For Husqvarna Parts Call 606-678 9623 or 606 561 4983 SERVICE 1 X 86.108-26

MODELS 61/266

CRANKSHAFT – CLUTCH

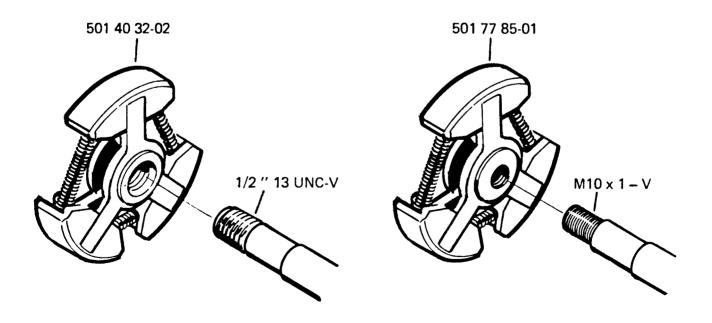
A new crankshaft with a changed thread for the centrifugal clutch is introduced. The thread is changed from 1/2" 13 UNC-V to M 10x1-V. This also means a new clutch,

The old crankshaft with thread 1/2" 13 UNC-V is excluded as a spare part. In order to avoid problems when exchanging the crankshaft, the new clutch is enclosed with the new crankshaft, when ordering spare parts,
